Comments of the
INFORMATION TECHNOLOGY INDUSTRY COUNCIL
to the
CALIFORNIA ENERGY COMMISSION
regarding
Battery Charging Specification

PROPOSED AMENDMENTS TO APPLIANCE EFFICIENCY REGULATIONS
CALIFORNIA CODE OF REGULATIONS, TITLE 20, SECTIONS 1601
THROUGH 1607 CALIFORNIA ENERGY COMMISSION

Docket Number 11-AAER-2

October 19, 2011

Fig 1. ENERGY STAR® v5 S5 source data (computer “standby/off”: system is plugged in with battery removed).

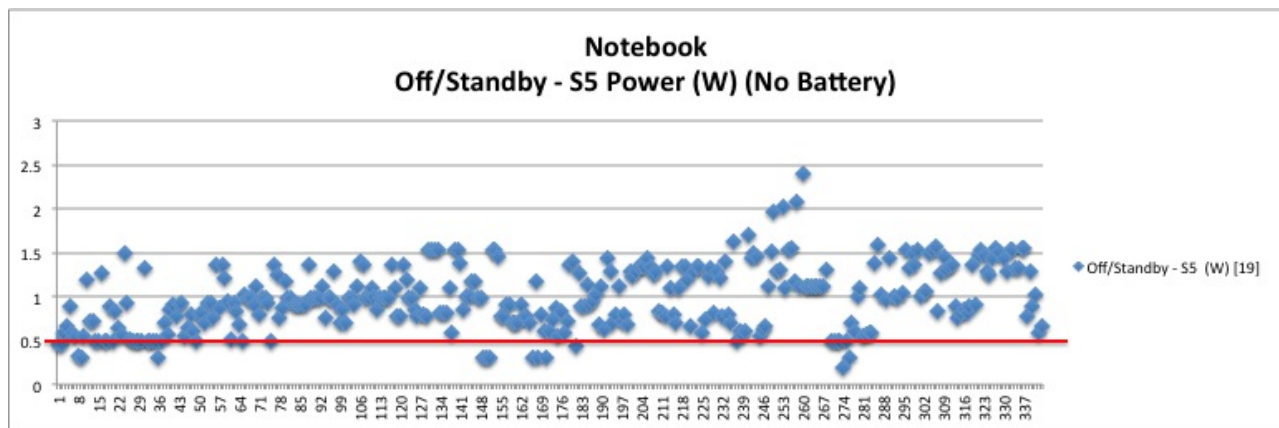
ITI noted the energy consumption in the off mode can be significant in a number of these mobile computing devices. The publically available data collected by the EPA to determine ENERGY STAR® for Computers v5.0 provides standby/Off state (without the battery) data on over 300 notebooks. Note that although technology has improved, the scope of products was limited and did not include those devices that primarily ran on battery power. The population of just notebook computers indicates that some devices were over 2W in off mode without the battery. Battery functions would be additive to these levels. It does not appear as though this data was taken into account during the limit setting analysis.

This data unfortunately, is without the battery. Battery functions and intelligent system controls are additive to the S5 levels.
